WARNING:

MODIFICATION OF THE TIMING COVER IS
REQUIRED BEFORE INSTALLATION OF
PART NUMBER 531101 FLUIDAMPR

P/N 4NFL02

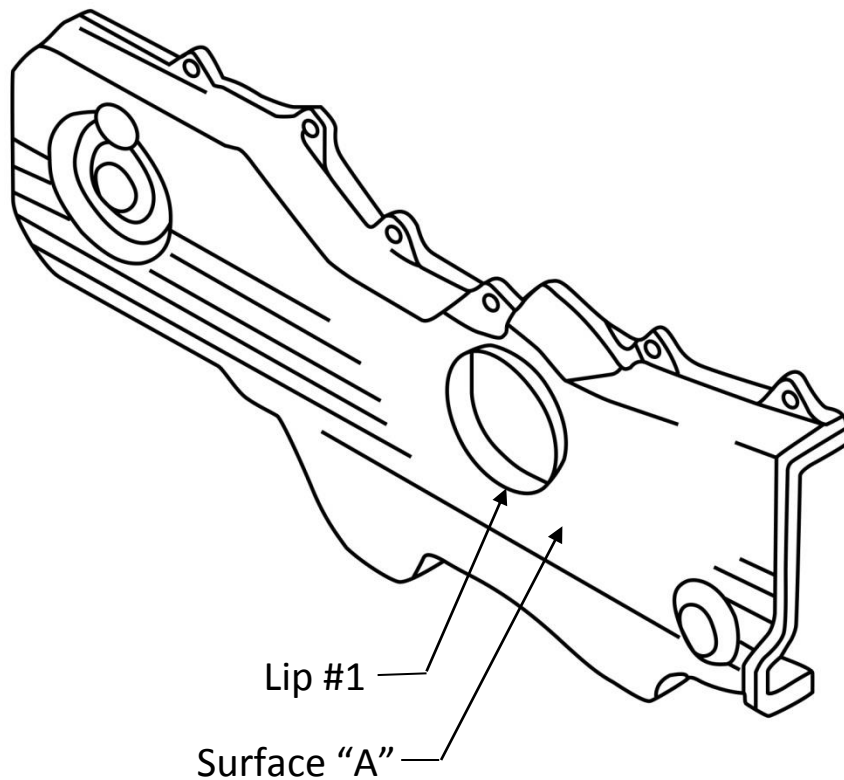
Cut, trim or grind lip #1 to be flush with surface "A", to clear the
back of the fluidampr.
